Annexure A

DETERMINATION OF APPLICATION FOR MODIFICATION OF DEVELOPMENT CONSENT

Modification Application No: DA13/2019/7

Description of modification to the development consent: Reinstatement of Unit 2 pool, addition of unit 8 plunge pool, adjustments to landscaping and the placement of canopy trees, changes to unit 7 balconies, removal of non-structural columns on level 2 rear balconies, rearrangement of proposed rooftop plant and equipment, and rationalisation of proposed retaining wall along the norther boundary.

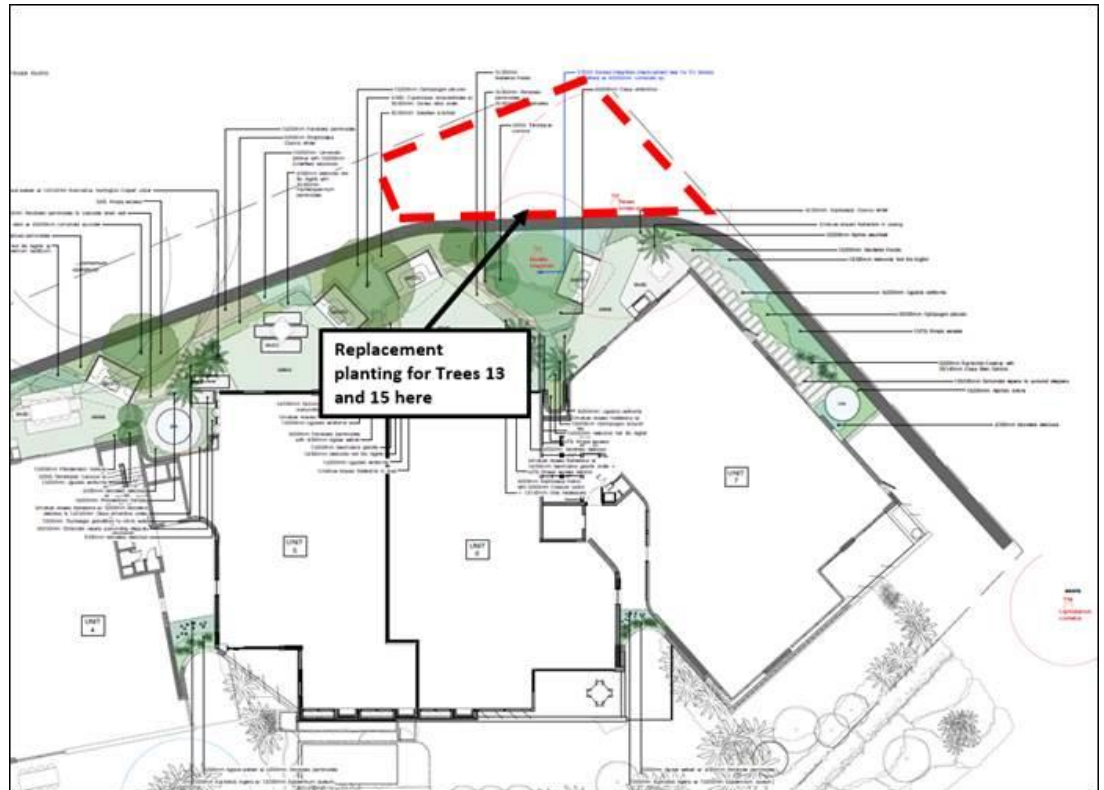
- j) To compensate for the loss of Tree 13 & 15 the landscape plan must include the following trees in a deep soil zone in the area indicated in the figure below:
(added under DA13/2019/6 and amended under DA13/2019/7)

The following replacement tree species must be planted indicated:

- 1 x *Banksia integrifolia* (Coast Banksia) or,
- 1 x *Tristaniaopsis laurina* 'Luscious';

AND

- 1 x *Angophora costata* (Sydney Pink Gum) or,
- 1 x *Corymbia eximia* (Yellow Bloodwood).

The replacement planting must comply with the following requirements:

- i. All trees must be supplied in a minimum container size of 200 litres at the time of planting.
- ii. To ensure replacement trees have the potential to grow to the minimum dimensions specified all trees must be planted in genuine deep soil areas and not over structures or basement car parking slabs.
